SERVICE INFORMATION BULLETIN

APPLICABILITY: 2015-19MY WRX
 2013-19MY BRZ

NUMBER: 12-271-19

SUBJECT: Rear Bumper Face Side Mounting Brackets-
 Design Change

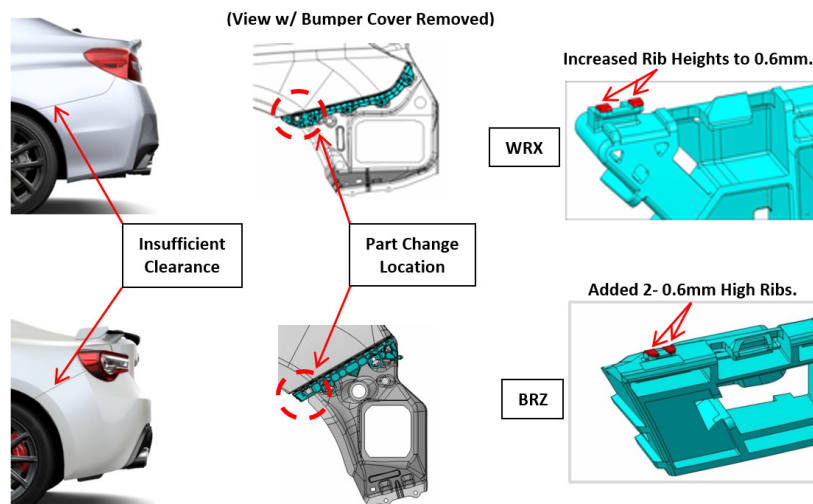
This Service Information Bulletin announces a design change made to the rear bumper cover side mounting brackets. These new brackets provide increased clearance between the edges of the bumper cover and the corresponding quarter panels. This change will prevent them from contacting each other and possibly damaging their painted surfaces.

The new mounting brackets were incorporated into production as per the table below:

Model	Starting VIN
WRX	K*827384
BRZ	K*601523
